**Planning Application Ref:** WA/77/19/T

**Location:** Walberton Place, Yapton Lane, Walberton, BN18 0AS

**Description of works:** Crown lift by 5m to 1no. mature oak tree. Crown lift and partial crown reduction by 1m and reduce south limb by 1m to 1no. mature oak tree

Figure 2 Positions of final cuts

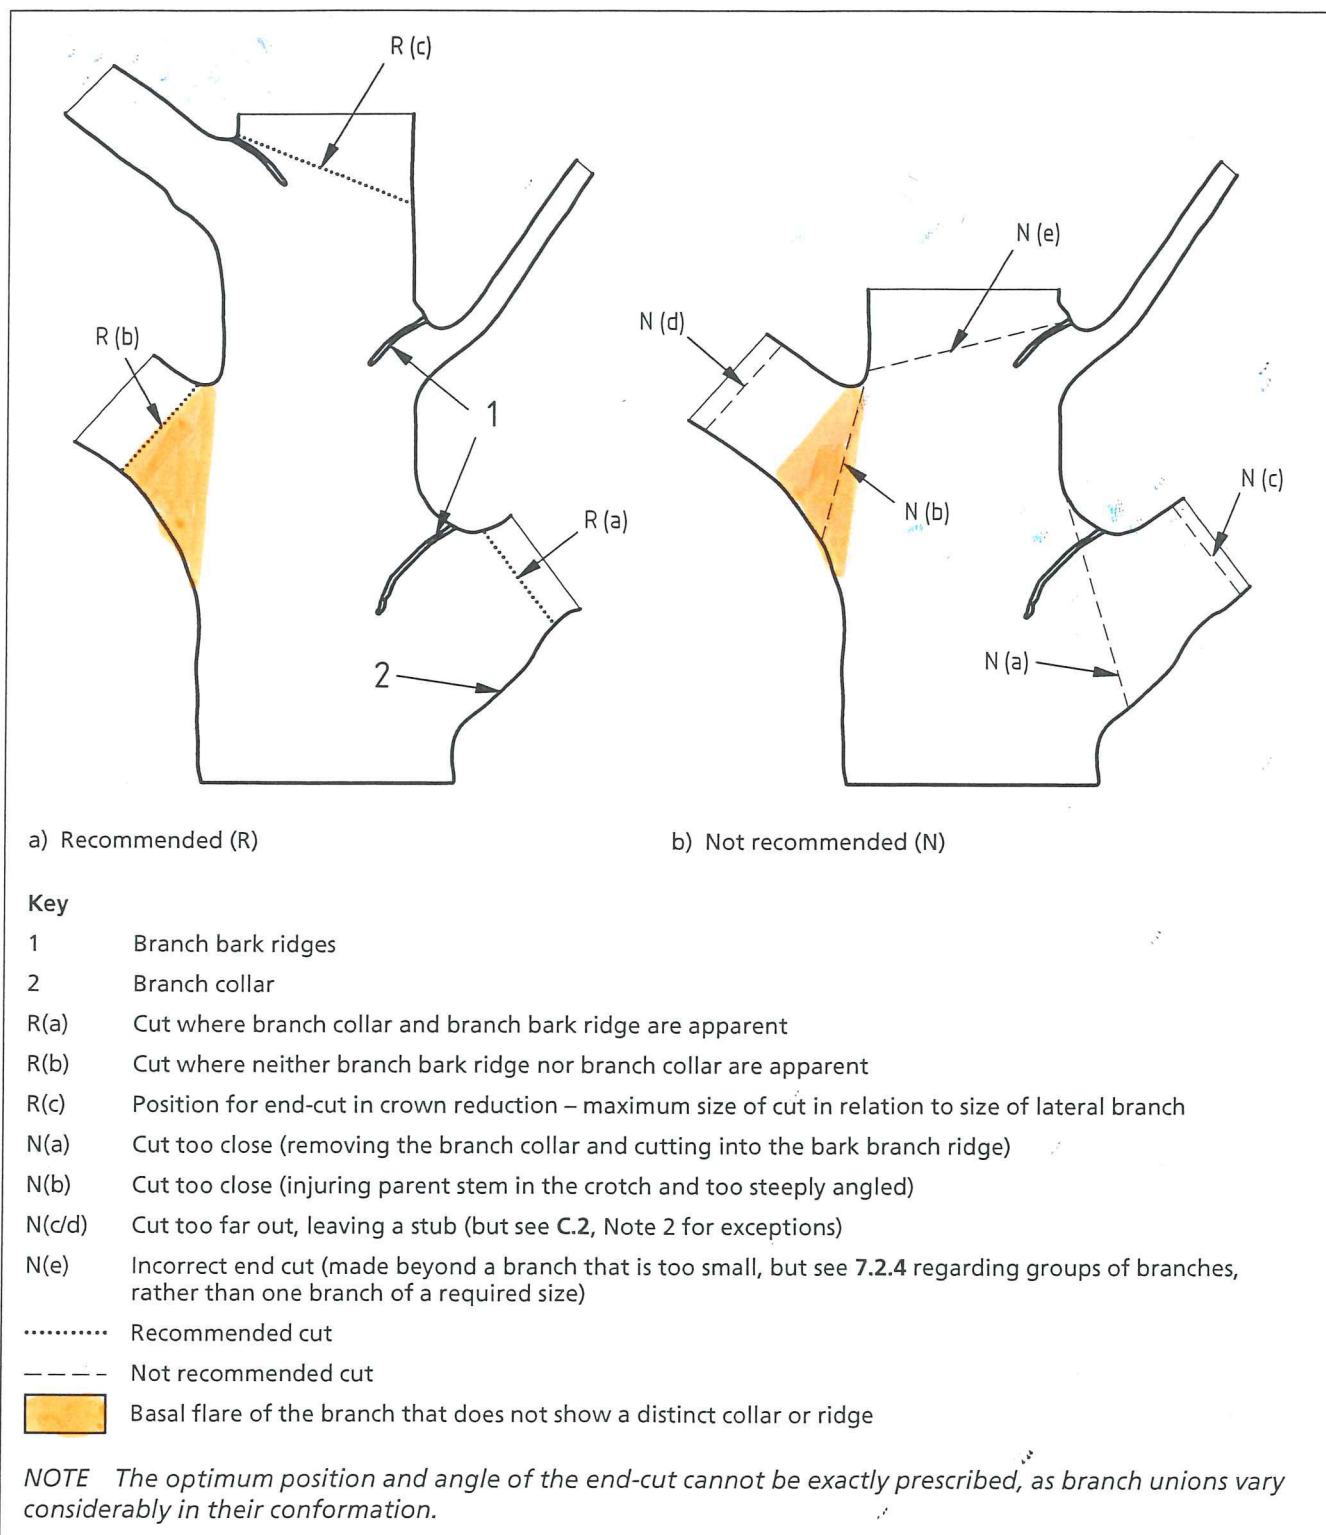
- Where whole branches are to be removed and final cuts made close to the trunk or branch union they are to be made as shown in Figure 2 of BS3998:2010
- Where branches are to be shortened back the final cuts are to be made at the correct angle shown in BS3998:2010 and adjacent to a live bud or lateral.
